Technical Service Information

FORD E4OD NEW DESIGN OVERDRIVE PISTON

Figure 1

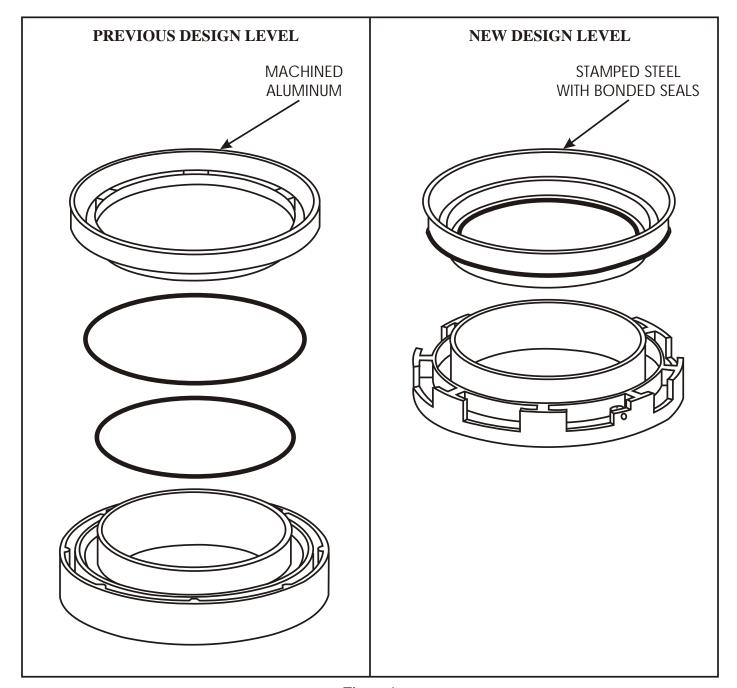
CHANGE: Some 1996-1997 vehicles equipped with the E4OD transmission were built with a new design level overdrive clutch piston, with the seals bonded to the piston (See Figure 1).

- (1) OVERDRIVE PISTON Now stamped steel with moulded rubber inner and outer seals on the piston assembly, instead of the previous machined aluminum, as shown in Figure 1.
- (2) OVERDRIVE/INTERMEDIATE CLUTCH CYLINDER Major casting changes to clutch cylinder, to accommodate the new design level bonded piston, as shown in Figure 1.

Both pieces listed above *will* retro-fit back on all previous models of the E4OD transmission, but *must* be used together as a package. New design parts are not interchangeable with previous design level parts on an individual basis.
